**PERFORMANCE BULLETIN 137**

**K531, K534, K535 Retaining Ring Update**

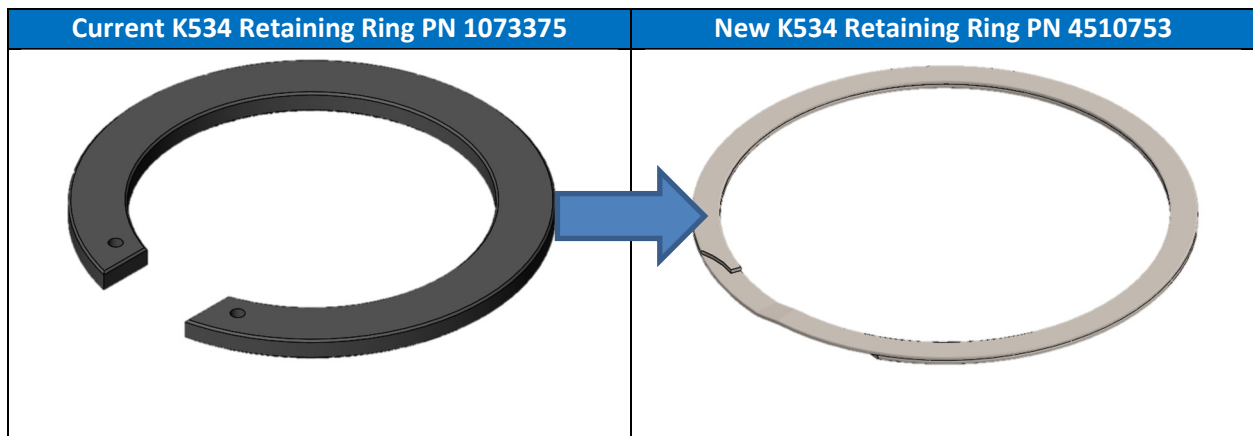
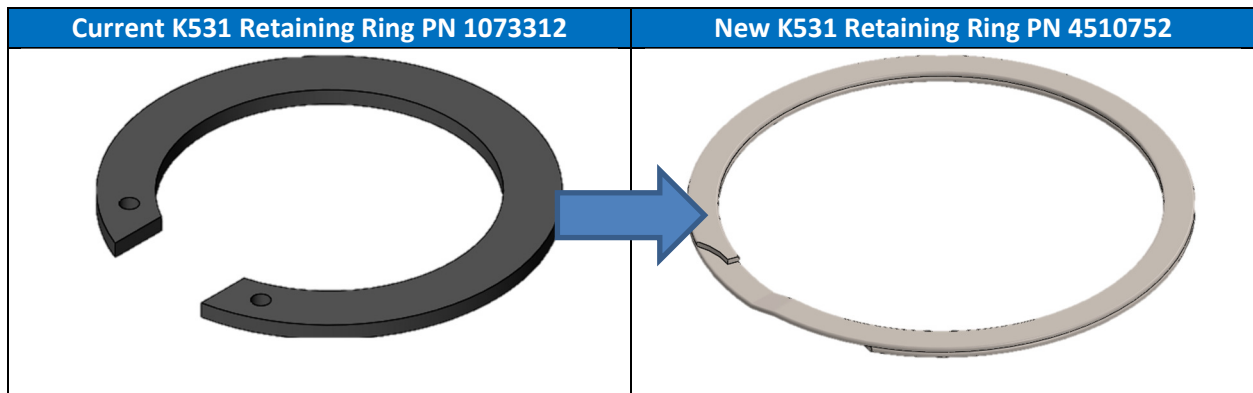
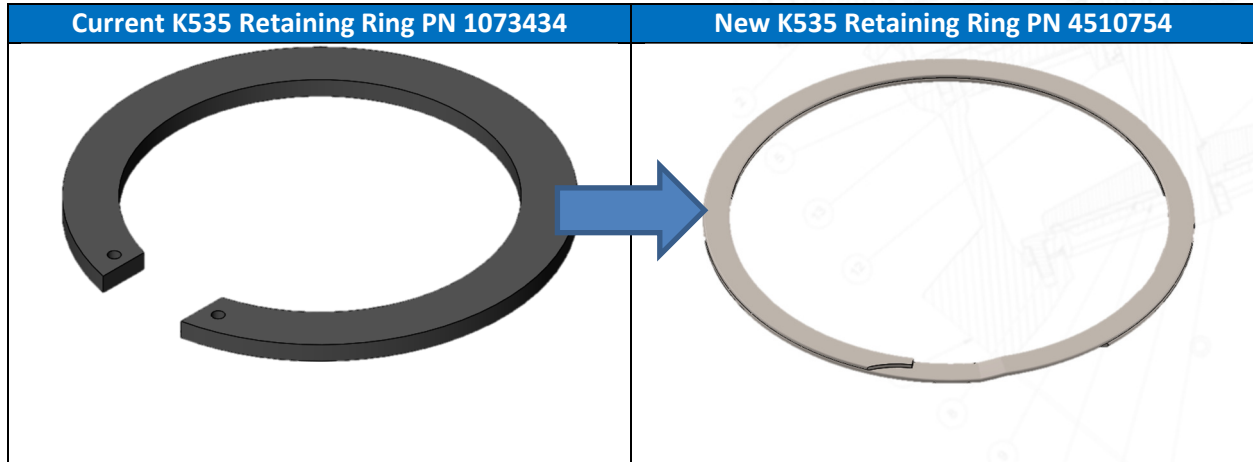
The Retaining Rings used on K531, K534, and K535 series valves are being updated from plastic to Stainless Steel. The new Retaining Rings will be fully interchangeable with the old and both fit into the same valve body groove.

The new Retaining Rings are similar to those used on K537 and K526 valves. A flat tipped screw driver is used to remove the Retaining Ring. No tools are required to install the rings. The update will be implemented when inventory of the current version is exhausted.
